**REPLACEMENT OF QUARRY ROAD BRIDGE
SUFFIELD, CT
ADDENDUM NO. 1
March 26, 2025**

1. Sign in sheet for mandatory pre-bid meeting held on March 20, 2025.
(4 pages)
2. Pre-Bid Meeting Agenda
(1 page)
3. Responses to questions and additional information discussed at the pre-bid meeting.
(1 page)
4. Answers to Questions Received by March 24, 2025.
(1 page)
5. Sheet No. 6 and Sheet No. 8 updated to reflect comment responses.
(2 pages)

NOSING ELEVATION

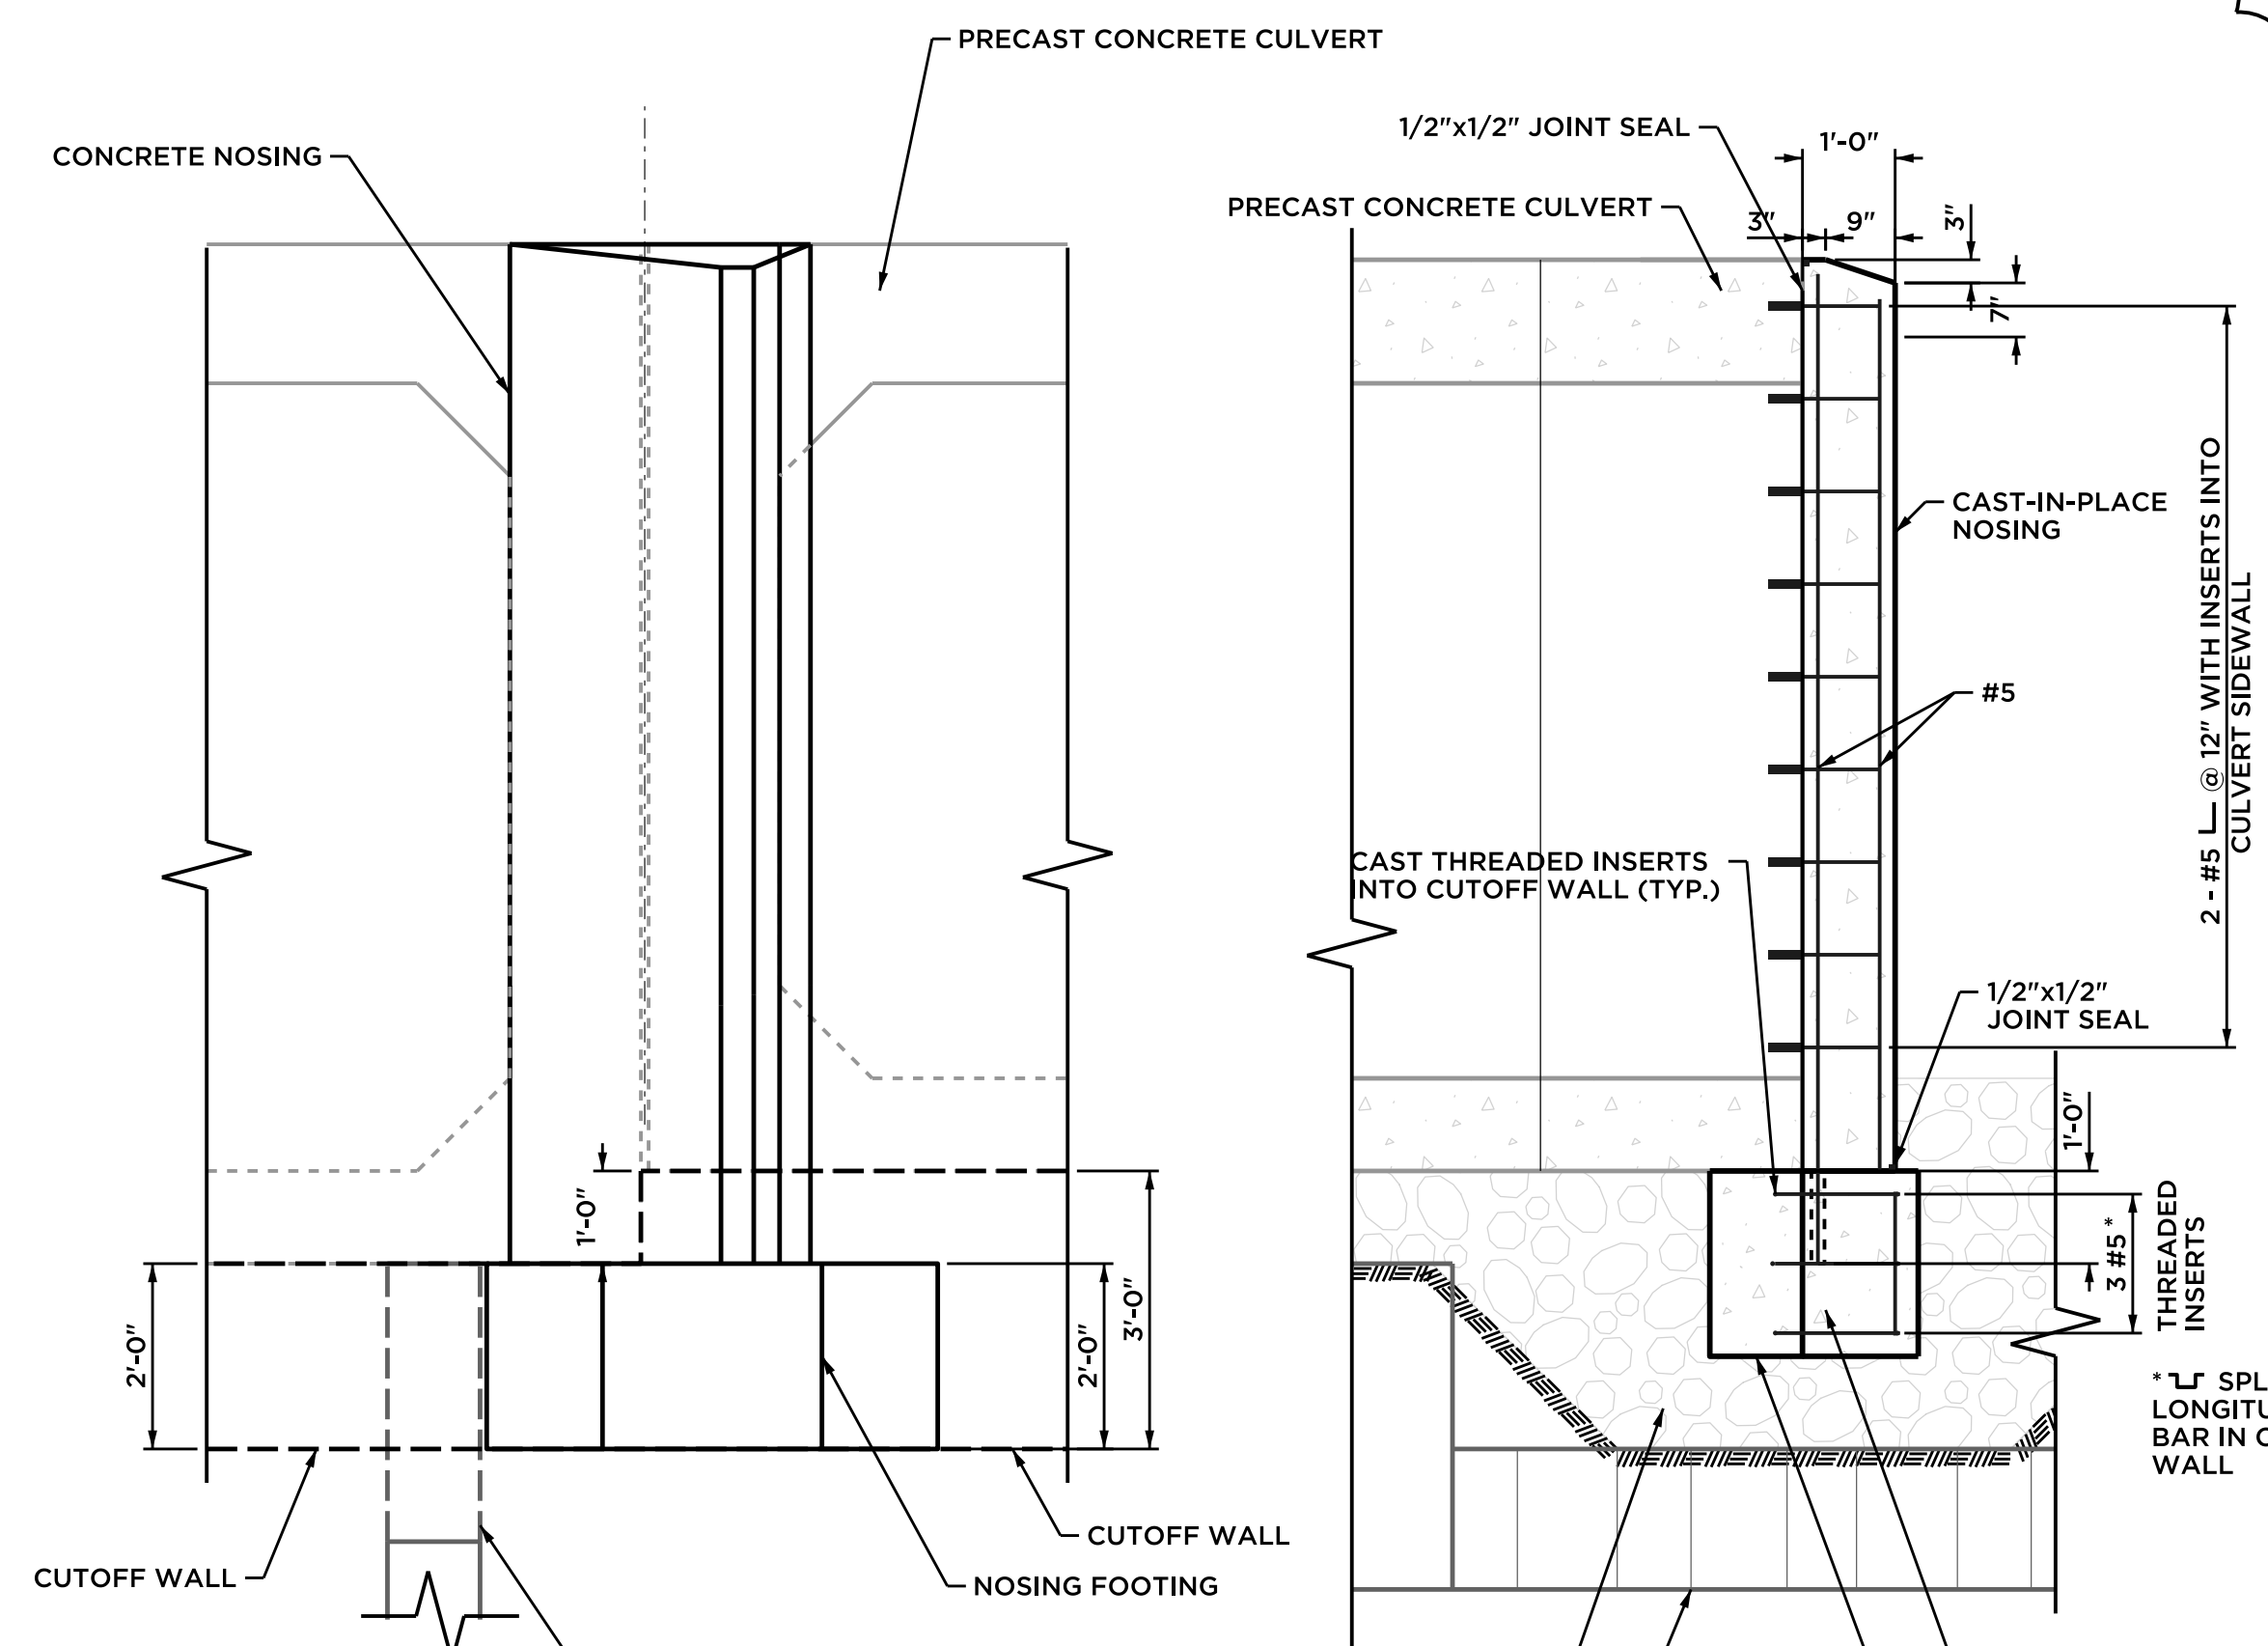
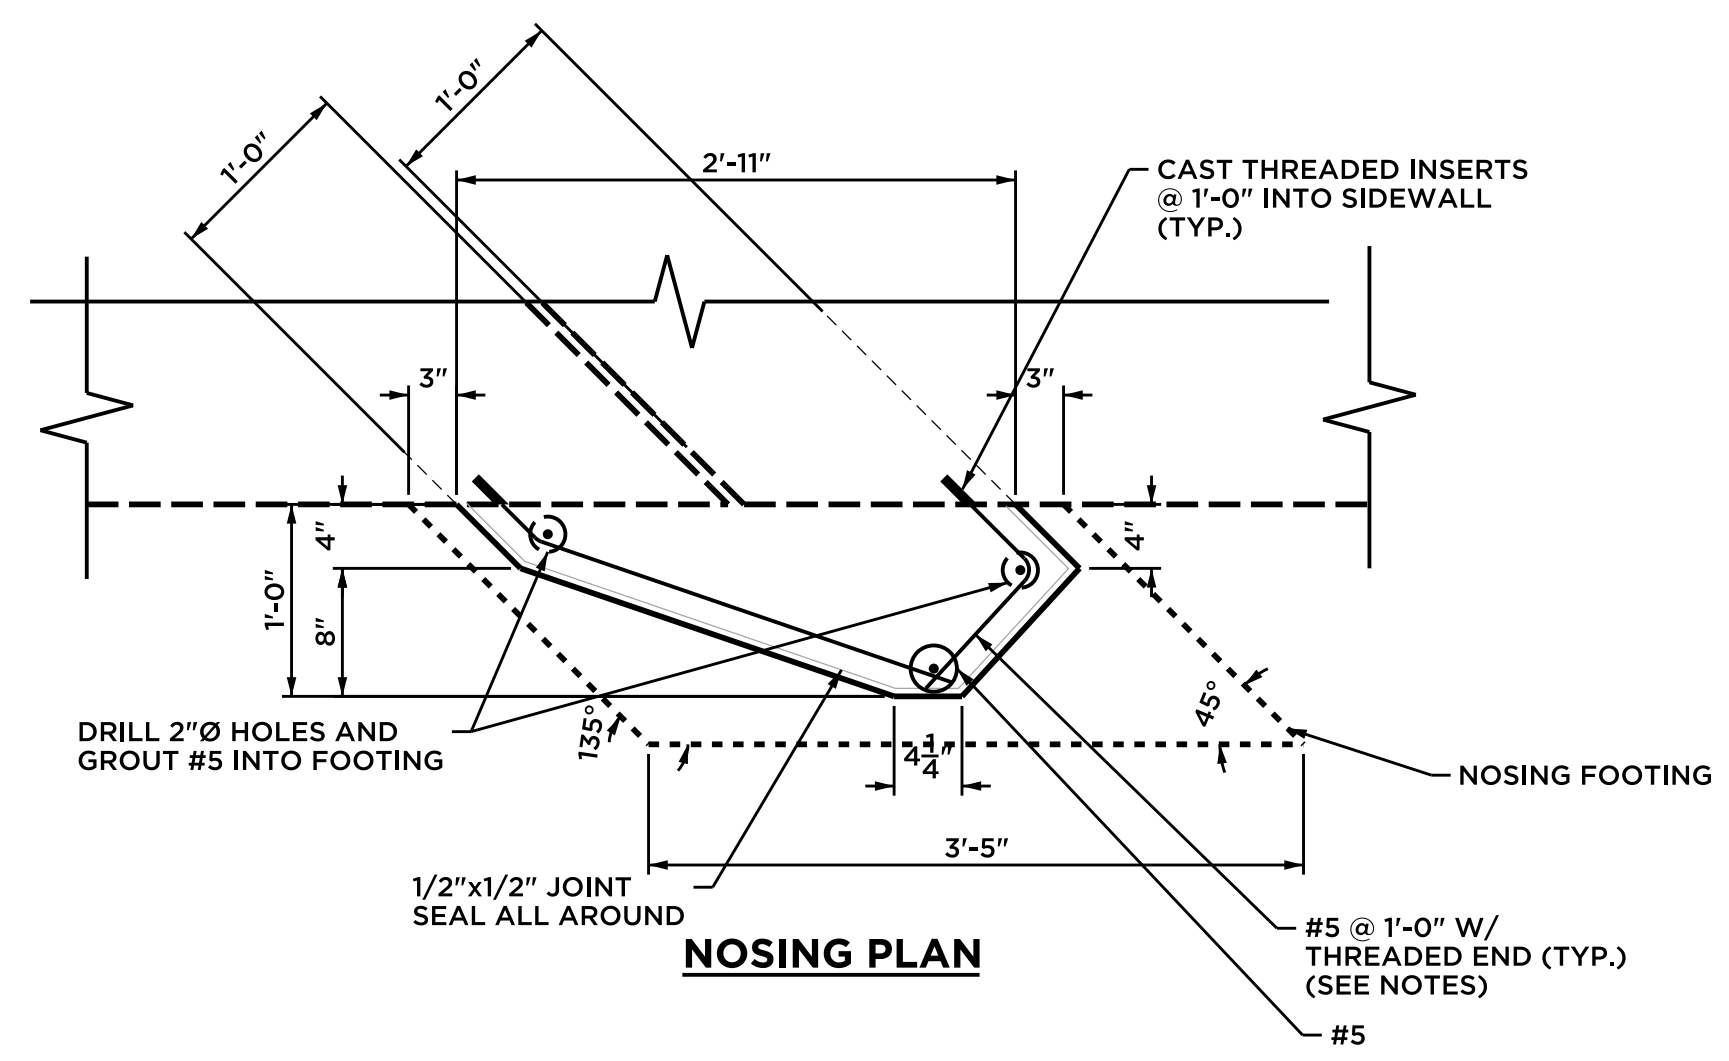
Question - The cutoff walls look to be shown as one complete unit on each end for both culvert runs. Typically these are built as a separate pieces under the end of each run. Then we will cast inserts in the face of each piece for the nosing to be cast-in-place for both the cutoff walls and the faces of the culverts to tie everything together.

Response – Sheet 6 has been updated to show two separate cutoff walls that will have threaded inserts cast into them to connect the nosing footing.

CURB/MOMENT SLAB ON WINGWALL SECTION B-B

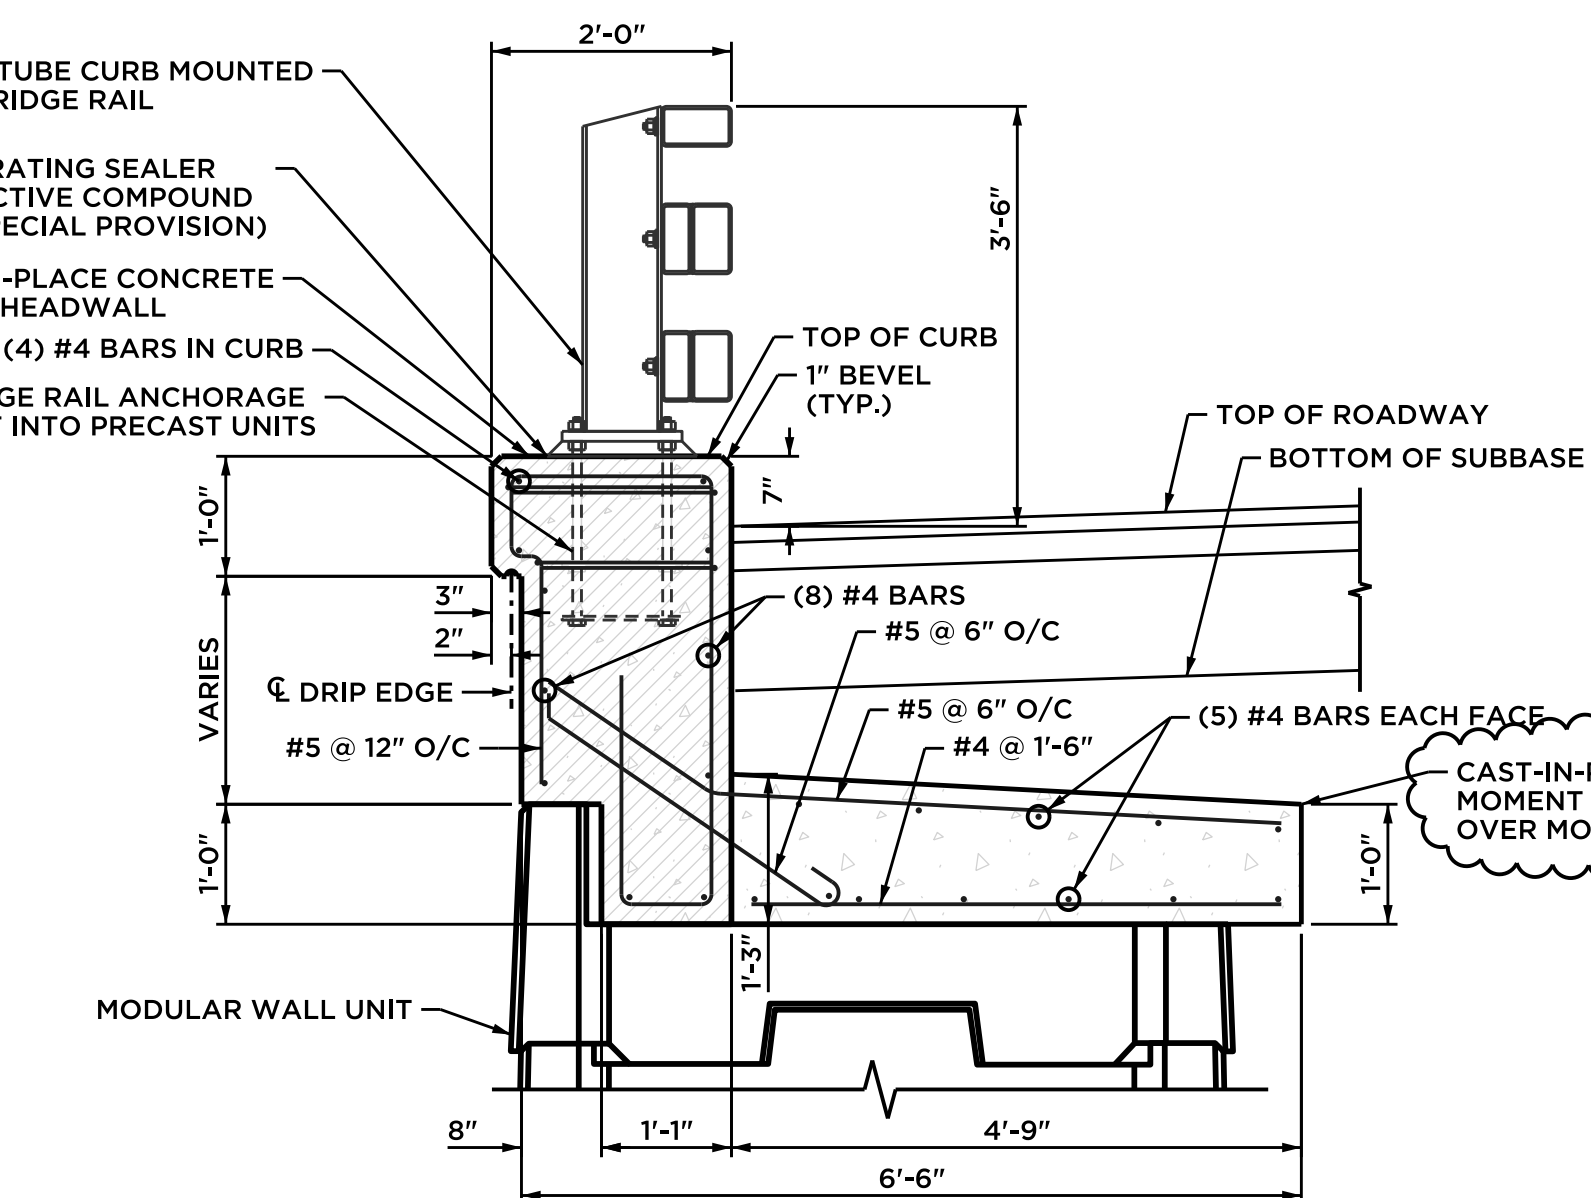
Question - Does the moment slab continue down the entire length of the wingwall or is it placed only 16' at either end of the box culvert? Sheet 8 of 13 / section BB curb moment slab on wingwall - Is the moment slab cast-in-place concrete or precast?

Response – Sheet 8 has been updated for clarity. The moment slab extends along the full length of the wingwalls.
